# UNITED STATES PATENT AND TRADEMARK OFFICE

APPLICATION NO.	FILING DATE	FIRST NAMED INVENTOR	ATTORNEY DOCKET NO.	CONFIRMATION NO.
10/665,447	09/22/2003	Tsuyoshi Kaneko	116898	7312
25944	7590	03/10/2006	EXAMINER	
OLIFF & BERRIDGE, PLC P.O. BOX 19928 ALEXANDRIA, VA 22320			NGUYEN, PHILLIP	
			ART UNIT	PAPER NUMBER
			2828

<b>Office Action Summary</b>	<b>Application No.</b> 10/665,447	<b>Applicant(s)</b> KANEKO, TSUYOSHI	
	<b>Examiner</b> Phillip Nguyen	<b>Art Unit</b> 2828

## **DETAILED ACTION**

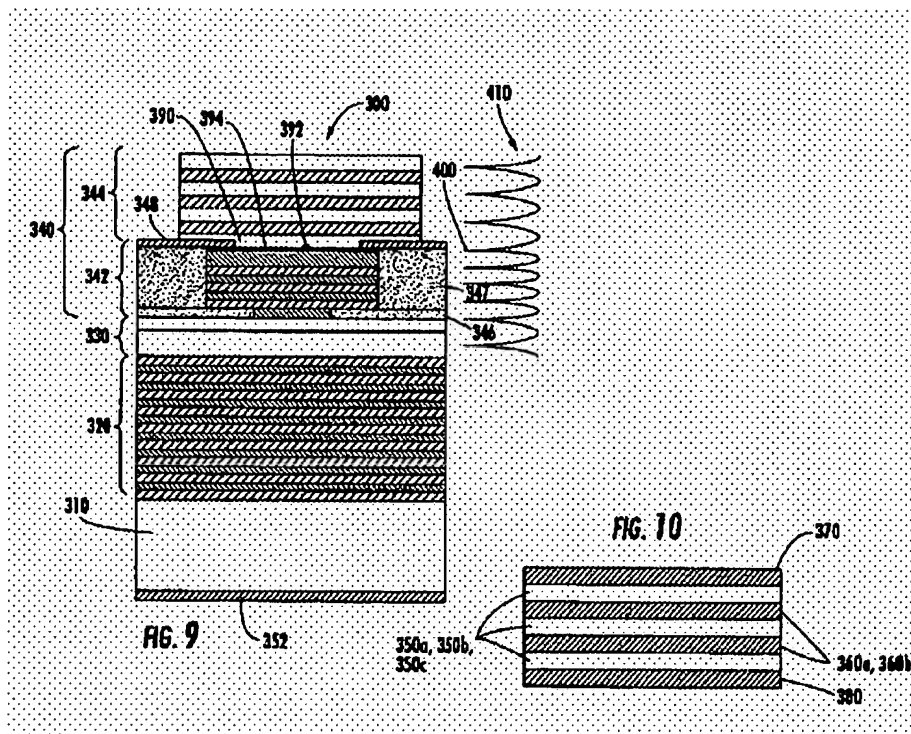
3. Claims 1-2, 6-8, 10, 15-17, and 22 are rejected under 35 U.S.C. 102(e) as being anticipated by Wasserbauer et al. ('414).

With respect to claims 1 and 6, Wasserbauer discloses in Fig. 9-10 a surface emitting semiconductor laser including a resonator formed on a substrate 318 and emitting a laser beam toward a direction vertical to the substrate from an emitting surface formed on an upper surface of the resonator, the resonator including a first mirror 320 formed above the substrate; an active layer 330; and a second mirror 342 located oppositely to the first mirror and sandwiching the active layer therebetween; a reflectivity adjustment layer 344 that is formed on the emitting surface; the second mirror including a layer of which an optical thickness is  $m_1 \lambda/2$  ( $m_1$ , a natural number), when a wavelength of the laser beam is  $\lambda$ , and an optical thickness of the reflectivity adjustment layer being  $(2m_2 - 1)\lambda/4$  ( $m_2$ , a natural number) and the optical thickness is  $\frac{1}{2}$  wavelength constituting a top layer of the second mirror (see col. 10, lines 28-30 and lines 52-56.)

With respect to claim 2, it is inherent that the reflectivity of the first region being higher than that of the second region since the first region include more layers of mirror such as layers 344.

With respect to claim 6, see col. 10, lines 52-56.

With respect to claim 7, since the reflectivity adjustment layer 344 being formed on the emitting surface of the laser, it is transparent to the laser beam so that the laser beam transmits through it to provide output.

With respect to claim 8-10, Wasserbauer discloses in the cross section of the laser; however, the plane configuration of the reflectivity adjustment layer should be a circle. Wasserbauer further discloses the reflectivity adjustment layer being arranged coaxially with a center axis of the emitting surface as shown in the same figure.

With respect to claim 15, see the Fig. 9.

With respect to claim 22, Wasserbauer discloses the top layer of mirror 342 with the thickness of  $\frac{1}{2}$  wavelength being formed in the whole area of the second mirror 342, the reflectivity adjustment layer 344 being formed on a part of the mirror 342 because the electrode 348 is sandwiching in between.

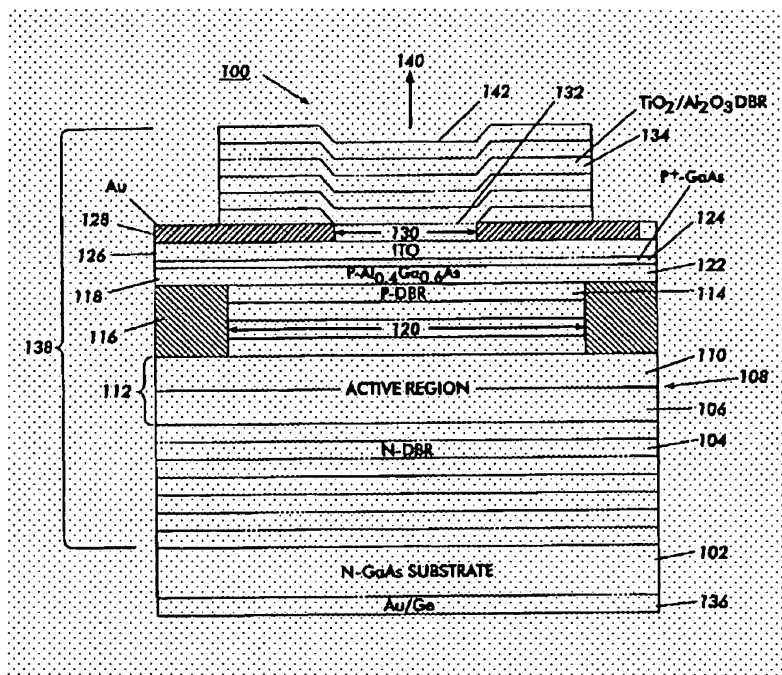
5. Claims 3- 4 are rejected under 35 U.S.C. 102(b) as being anticipated by Sun ('241).

With respect to claim 3, Sun discloses in the above figure a surface emitting semiconductor laser including a resonator formed on a substrate 102 and emitting a laser beam toward a direction 140 vertical to the substrate from an emitting surface formed on an upper surface of the resonator, comprising: a first electrode 128 and second electrode 136 that inject electric current into the resonator, at least a part of the first electrode being formed on the upper surface of the resonator; and an aperture 130 that is formed on the upper surface of the resonator, the emitting surface being formed within the aperture, and a reflectivity adjustment layer 134 being formed on the emitting surface; a thickness of the reflectivity layer being uneven.

With respect to claim 4, Sun discloses the resonator including a first mirror 104 formed above the substrate, an active layer 108, and a second mirror 114 located oppositely to the first mirror and sandwiching the active layer therebetween, and reflectivity of the laser beam in the first region being larger than that of a second region, when the first region is defined as a region comprising the reflectivity adjustment layer and a lower region of the reflectivity adjustment

layer in the second mirror, and the second region is defined as a region except the first region in the second mirror. It is noted that the region that is equivalent size with reference 130 and below it is considered as the first region and the second is the area except the first region therefore it is inherent that the reflectivity of the first region has to be higher than that of the second region since the second region is blocked by the electrode 128 which produce no reflectivity.
